**PCN#20151006002  
Conversion to smaller reel (13" to 7") and associated packing materials  
on Select Devices currently shipped in 13" reels  
Final Change Notification**

**Date:** 10/22/2015  
**To:** Newark/Farnell PCN

**20151006002**  
**Attachment: 1**

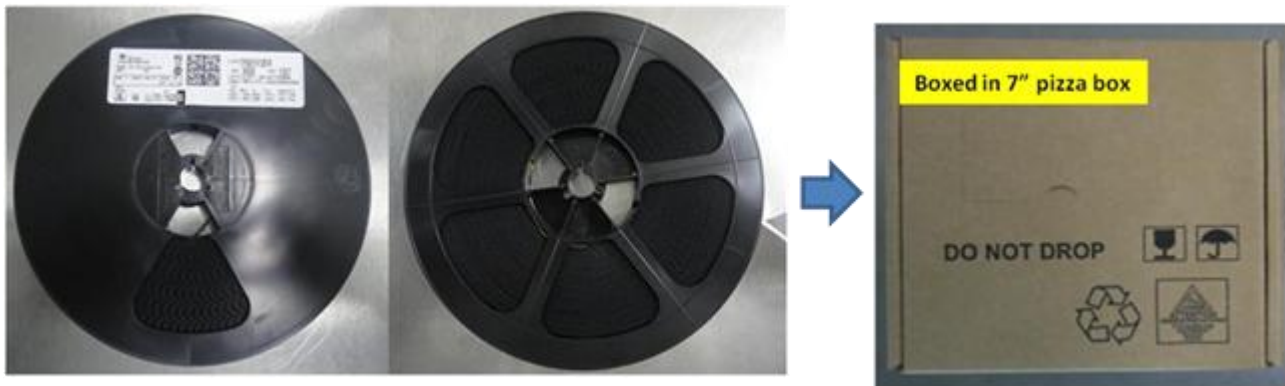
Conversion to a smaller reel size for selected product currently shipped in 13" reels with small reel quantities. The Moisture Barrier Bag (MBB) and pizza box will be switched to accommodate the smaller reel size. All new packing materials are qualified and currently in use for other products. Pack material differences are shown below:

Current Packing – 13 inch reel diameter

Proposed Packing – 7 inch reel diameter

Pack BOM	From	To
Reel Diameter	13"	7"
Pizza Box	4041330	4206831
